**ADDENDUM NO. 2**

Date of Addendum: February 7, 2023

Project Name: Gaston County Schools – Grier Middle School

- A. Owner: Gaston County Schools
- B. Architect: LS3P
- C. Architect Project Number: 9201-218240

C7.5

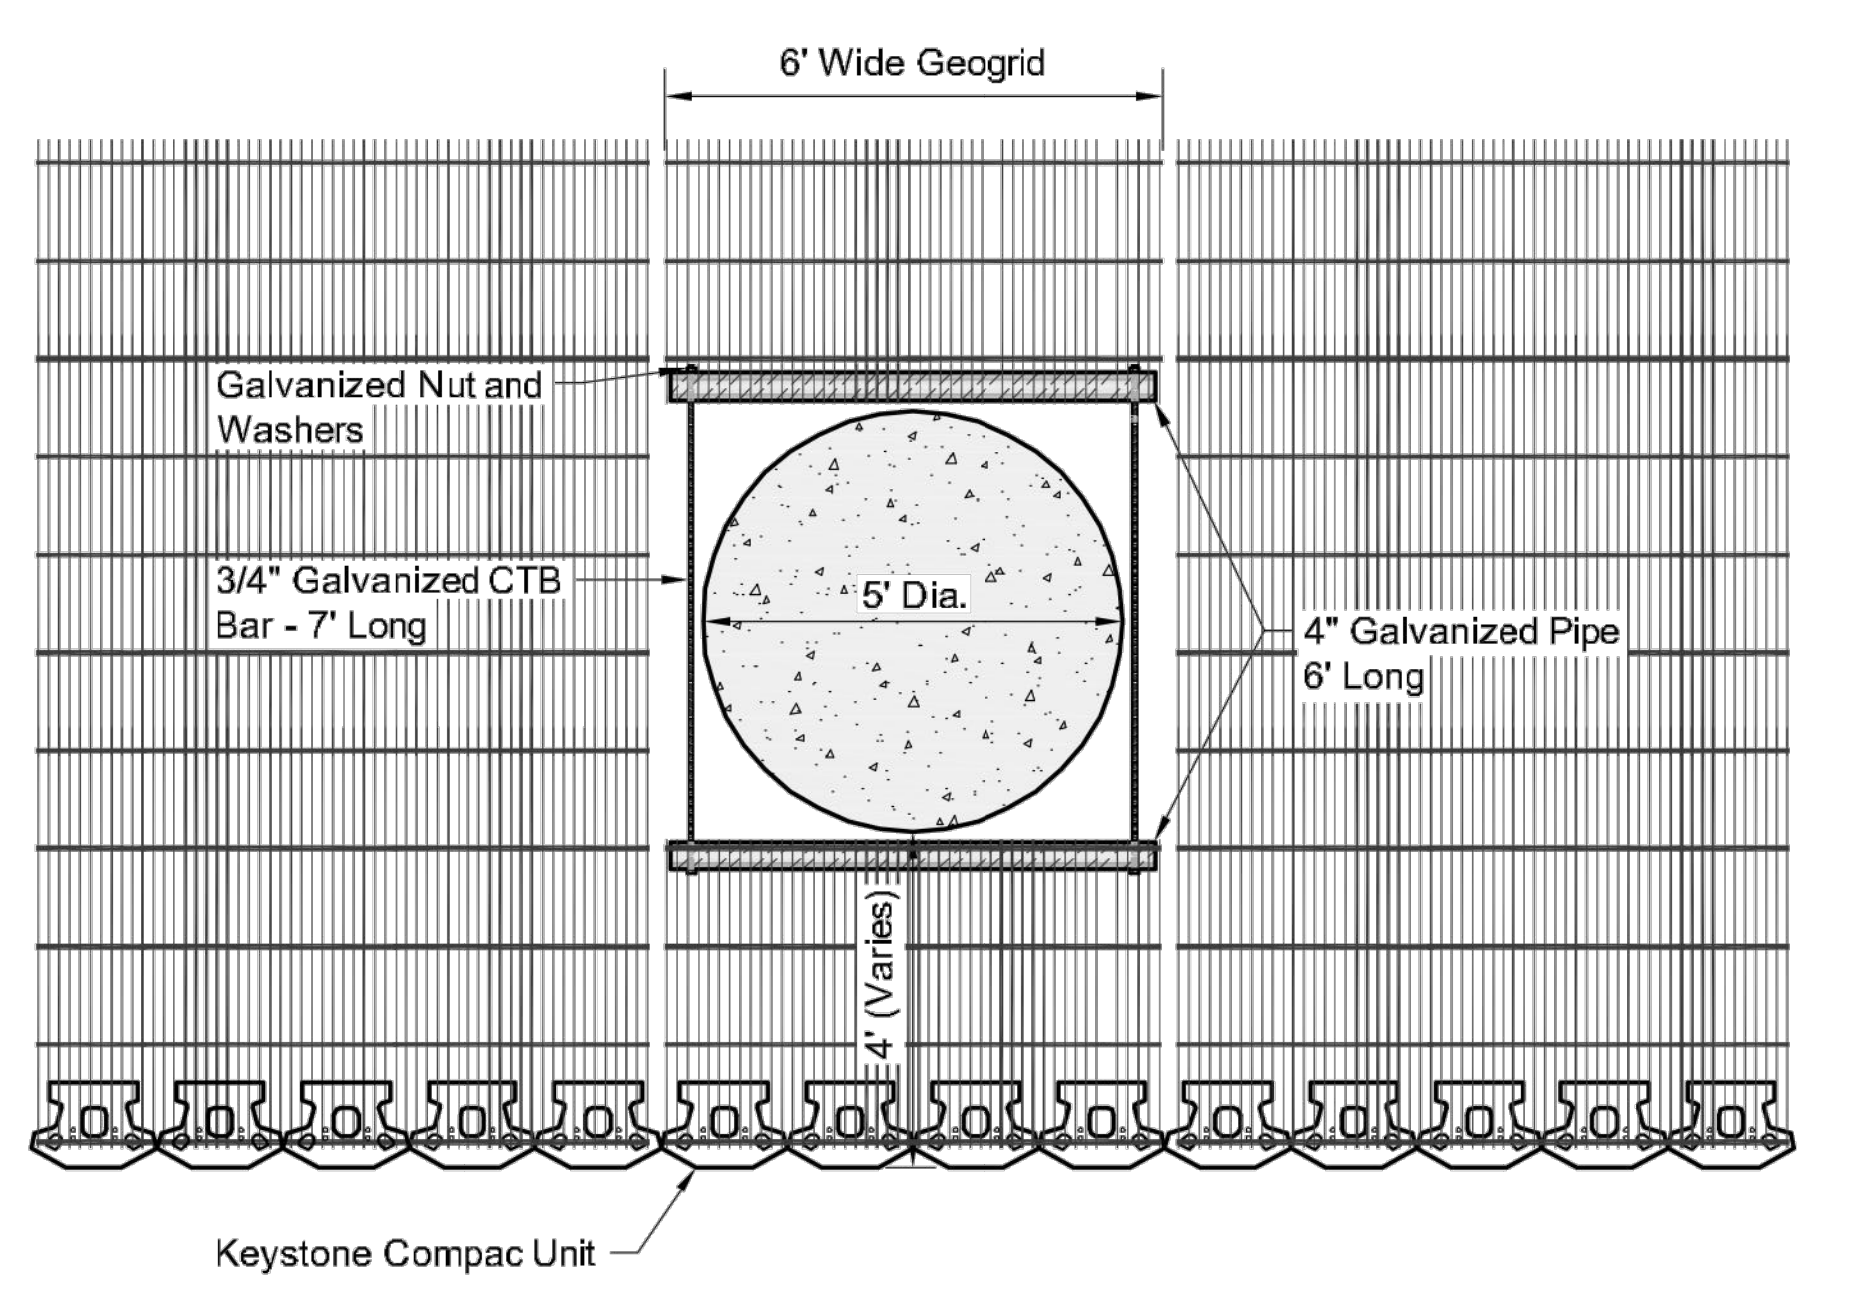
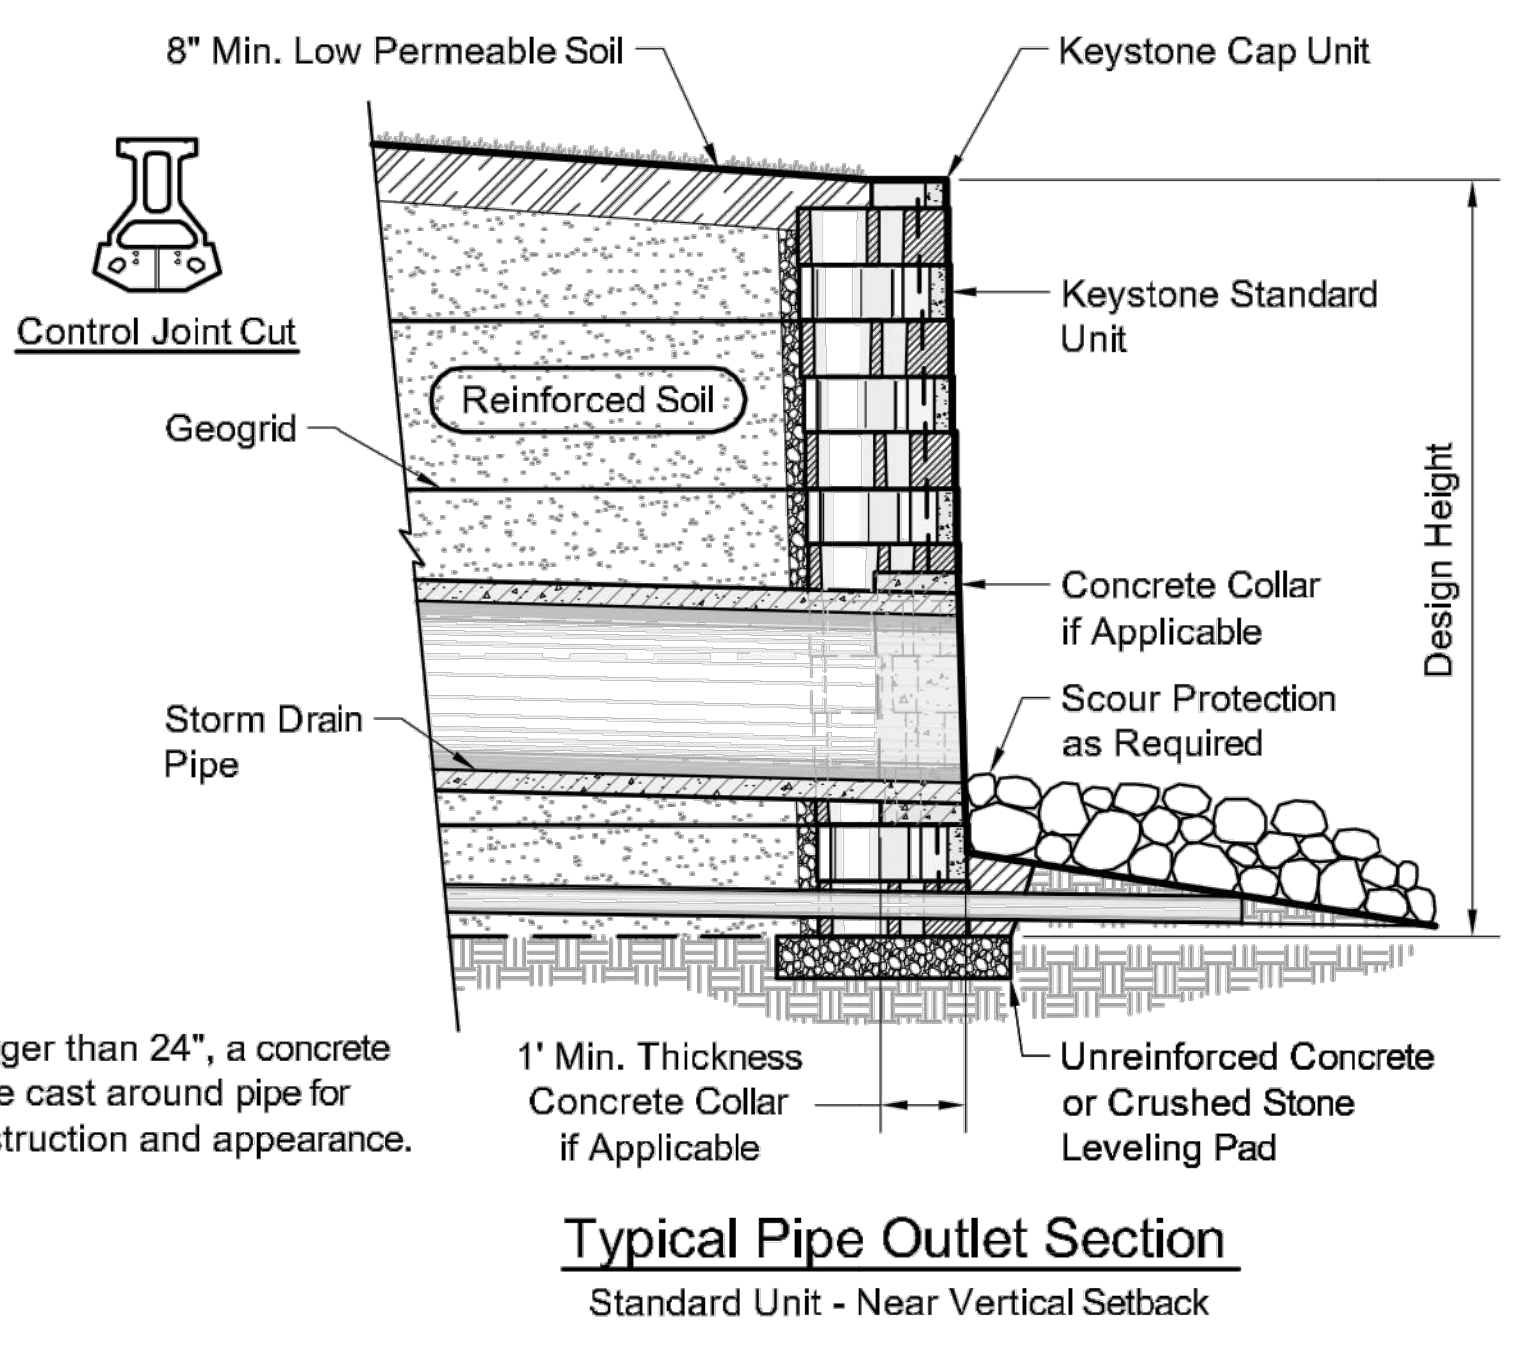
2. Add Detail #9, 35' Flag Pole.
  - L. Add SHEET C7.5 – SITE DETAILS, included in the attachments.
    1. Typical retaining wall details for reference only.

**WATER & SEWER PLAN**  
**C8.0**

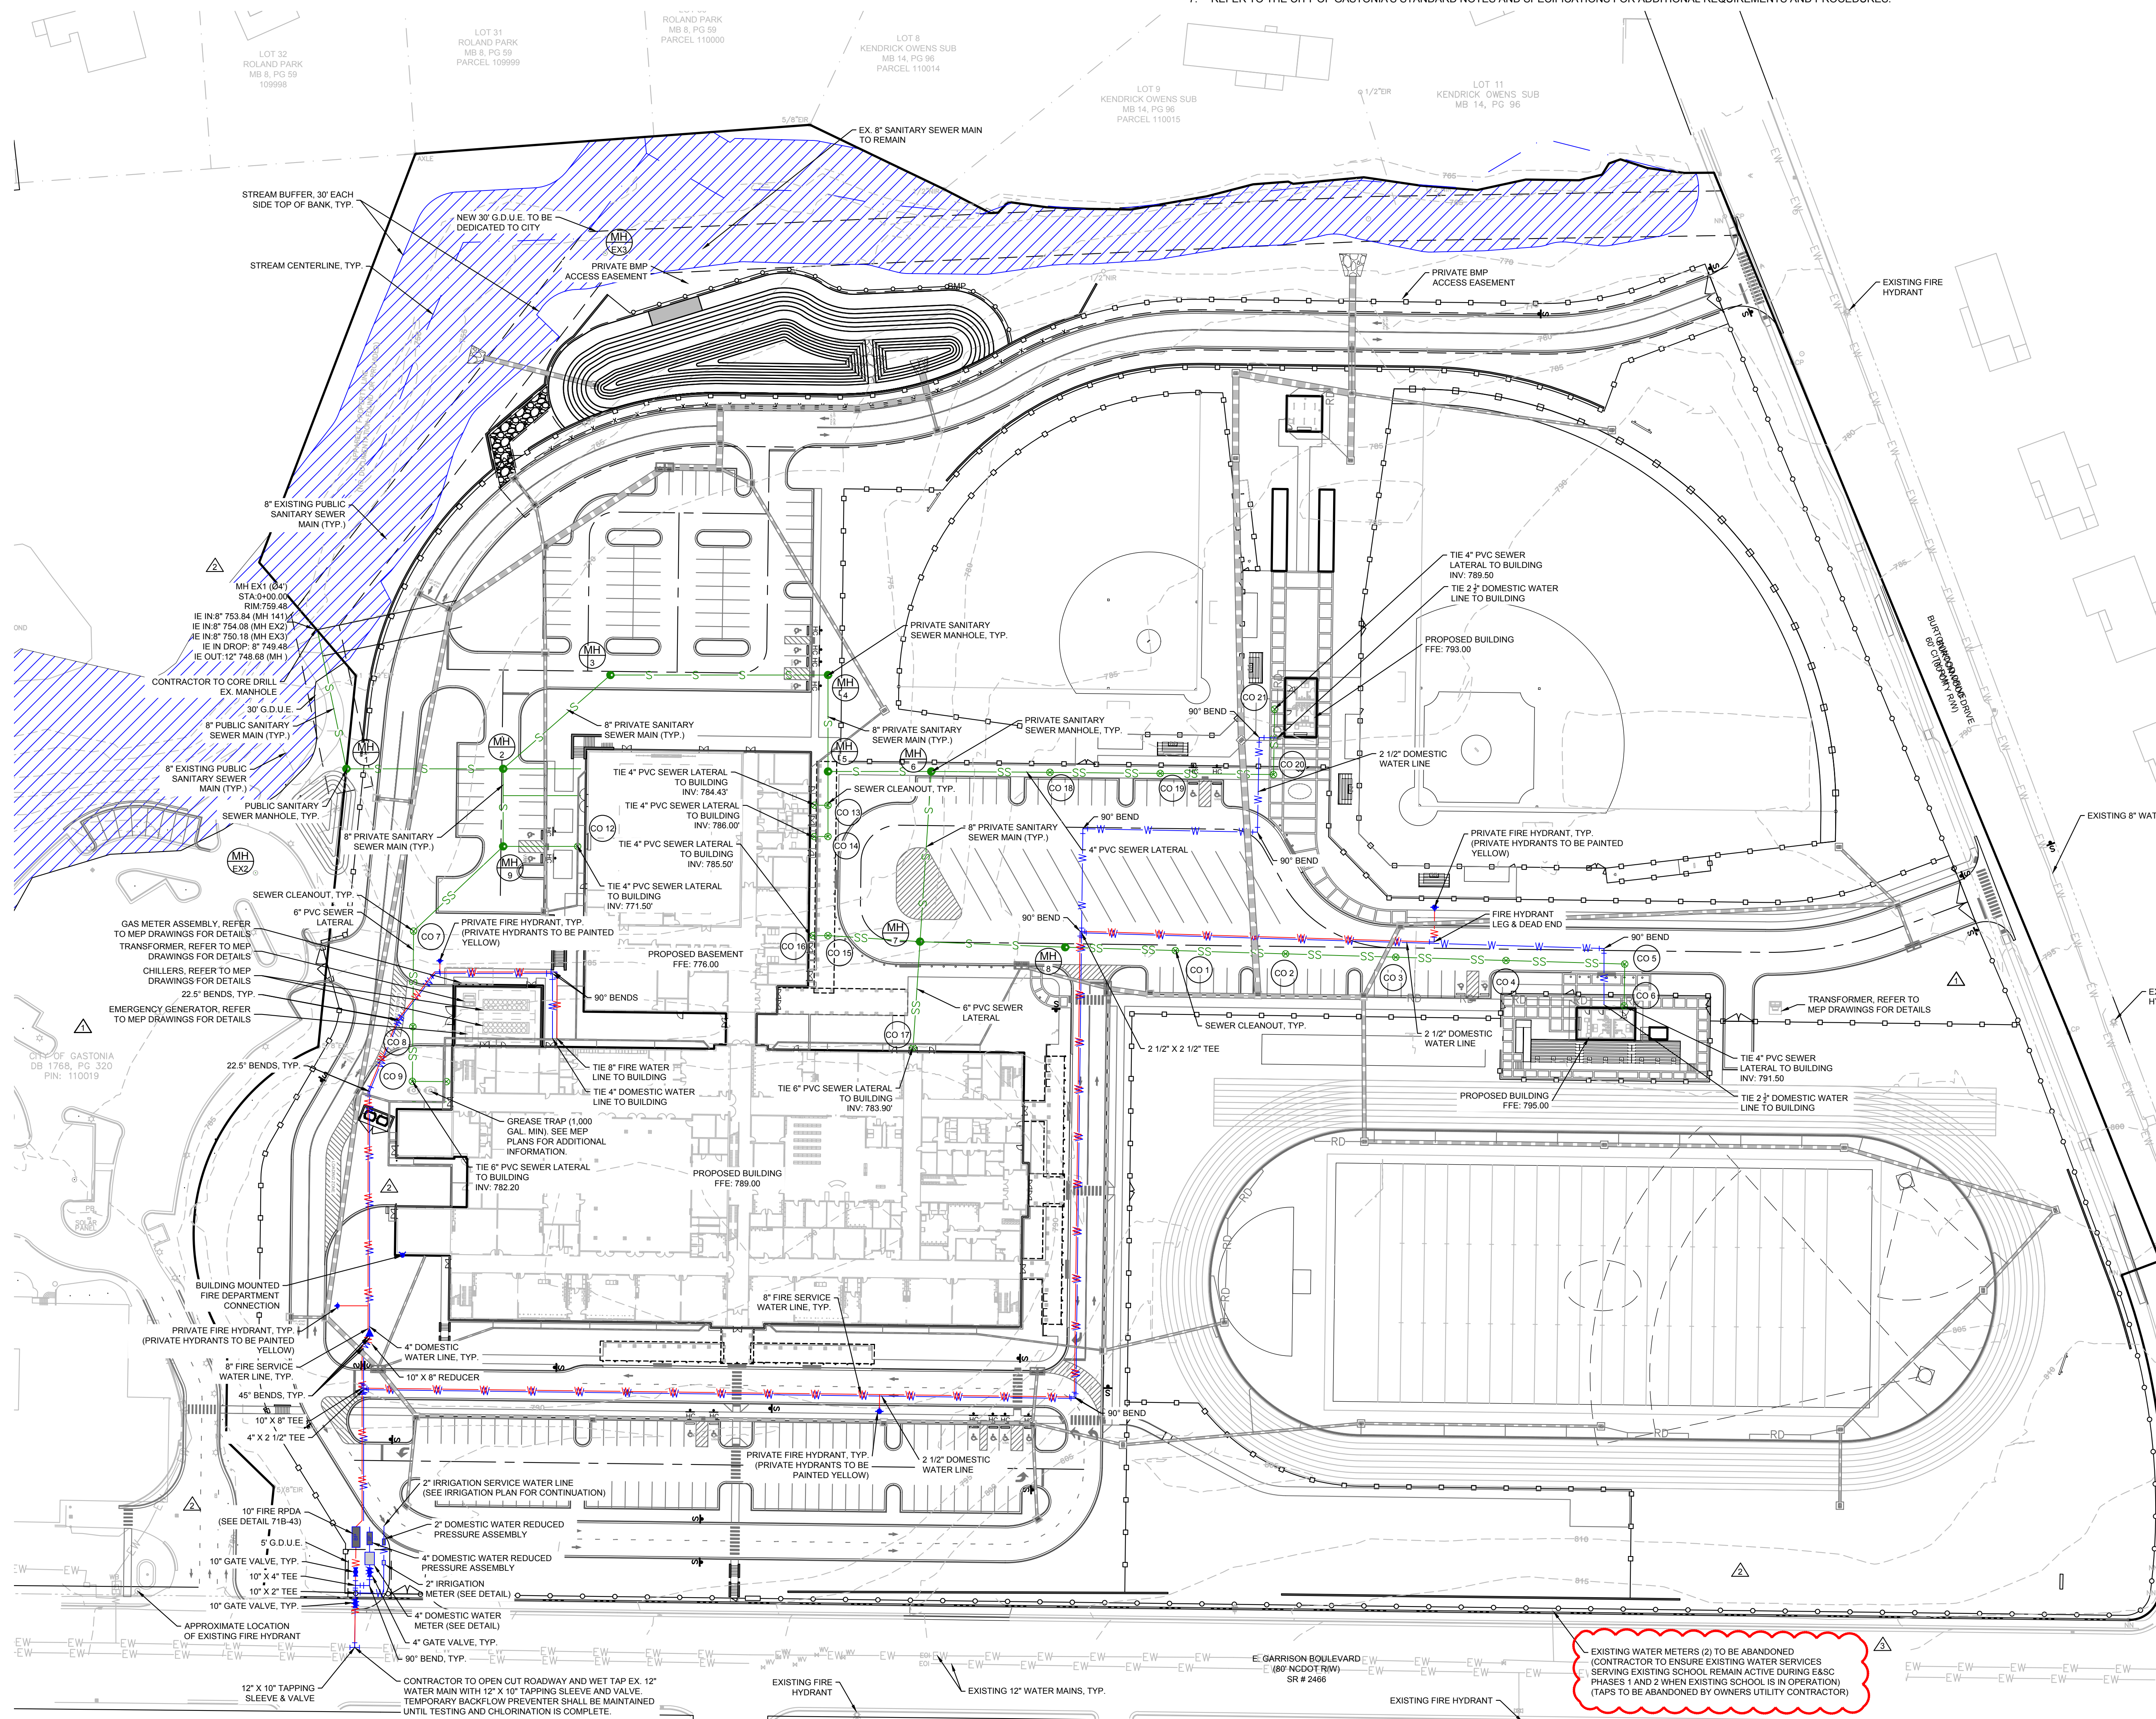
- M. Replace SHEET C8.0 – WATER & SEWER PLAN with revise Sheet C8.0, included in the attachments.
    1. Update label to reflect new survey information (2 water meters found in same vault).
